Technical Service Bulletin

SUBJECT: NO "READY" MODE IN EXTREME COLD WEATHER			No: TSB-12-54-016
			DATE: December, 2012
			MODEL: 2012 i-MiEV
CIRCULATE TO:	<input type="checkbox"/> GENERAL MANAGER	<input checked="" type="checkbox"/> PARTS MANAGER	<input checked="" type="checkbox"/> TECHNICIAN
<input checked="" type="checkbox"/> SERVICE ADVISOR	<input checked="" type="checkbox"/> SERVICE MANAGER	<input checked="" type="checkbox"/> WARRANTY PROCESSOR	<input type="checkbox"/> SALES MANAGER

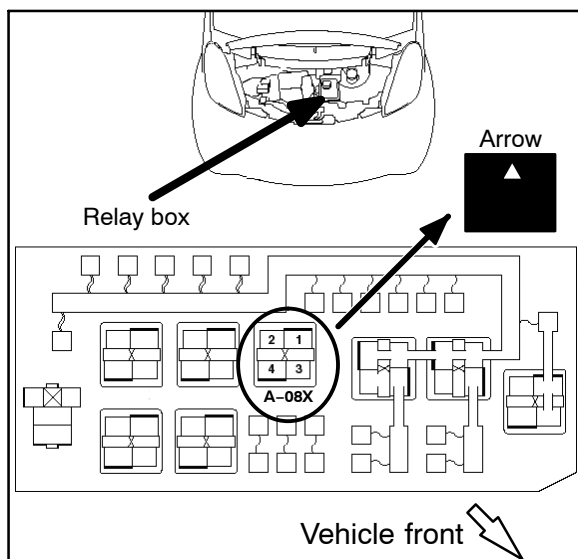
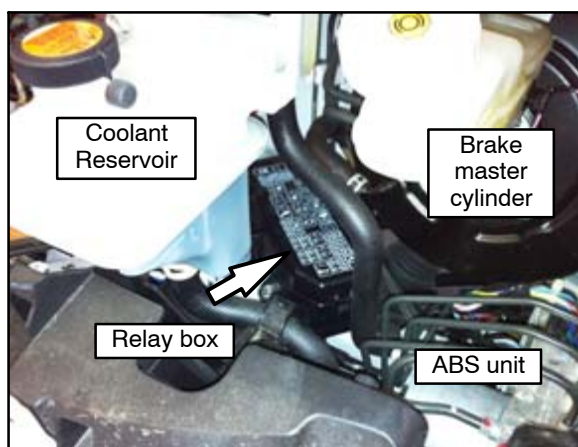
4. Disconnect the negative (—) 12V battery cable.
 5. Remove the relay box cover. The relay box is located under the hood below the brake master cylinder.

6. Replace the EV control relay (relay socket A-08X) with an improved part. Refer to the Parts Information section of this TSB for details.
- !! IMPORTANT !!** Take note of the arrow (Δ) on top of the relay. Install the new relay with the arrow pointing in the same direction.
